ALERT SERVICE BULLETIN ASB No. AA-00119

SUBJECT: **AFT CROSSTUBE ASSEMBLY:**
P/N 212-320-104 Low Skid Gear
P/N 212-321-104 High Skid Gear
Installed on Bell 205A, 205A-1, 205B, 212
Model Helicopters

DESCRIPTION: This Alert Service Bulletin is being issued to
require a one time inspection of the Crosstube
Upper and Lower Supports for evidence of de-
bonding and/or movement, a torque check of the
Support U-Bolts, and to provide procedures for re-
bonding the Supports if they are found to be
loose.

FIGURE 1

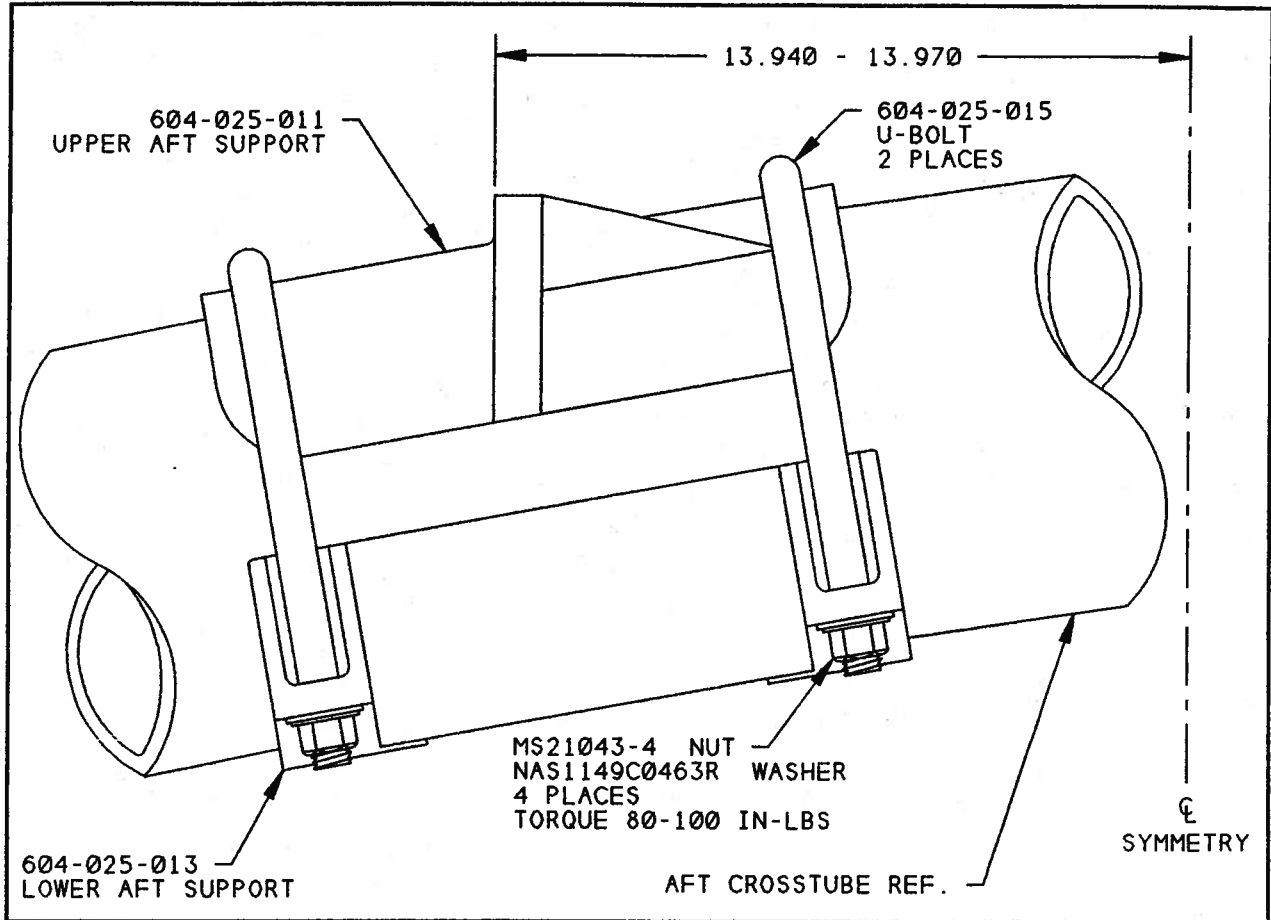
1. Inspect Aft Crosstube Assembly for evidence of de-bonding and/or movement of the Upper and Lower Supports. If evidence of de-bonding and/or movement is found, complete the PART 2 procedures.
2. Check torque (80-100 in-lbs) on U-Bolt nuts, re-torque as required

1. Remove the landing gear from the aircraft.
2. Remove the Support U-bolts from the Crosstube Assembly.
3. Remove the Supports from the Crosstube Assembly. Use of a heat gun to soften the sealant may facilitate removal.

4. Using a plastic scraper, remove the old sealant from Crosstube and Supports. Clean with a clean cloth and alcohol.

Inspect the Nylon coating on the faying surface of the Supports for condition. Replace Supports if coating has separated or has worn through.

5. Scuff the faying surface of the Crosstube and the Supports with 180 grit abrasive paper. Do not remove paint from the Crosstube or Nylon Coating from the Supports.
6. Clean the sanding residue from the Crosstube and Supports using alcohol and a clean cloth.
7. Apply a layer (approx. 1/16 inch) of sealant (MIL-S-8802 Type 2, Class B2 or equiv.) to inside surface of the Supports prior to assembly.
8. Reassemble the Upper and Lower Supports and the U-Bolts on the Crosstube, Refer to Figure 1.
9. Remove excess sealant and wipe clean after assembly.
10. Torque the U-bolt nuts to 80-100 in.lbs. (9.0 to 11.0 Nm) within 30 minutes after application of sealant. Check torque on the U-bolts after the sealant has cured (72 hours at room temperature). Re-torque as required.

Flight/landing operations prior to full sealant cure (72 hours at room temperature) could result in Crosstube Support movement.
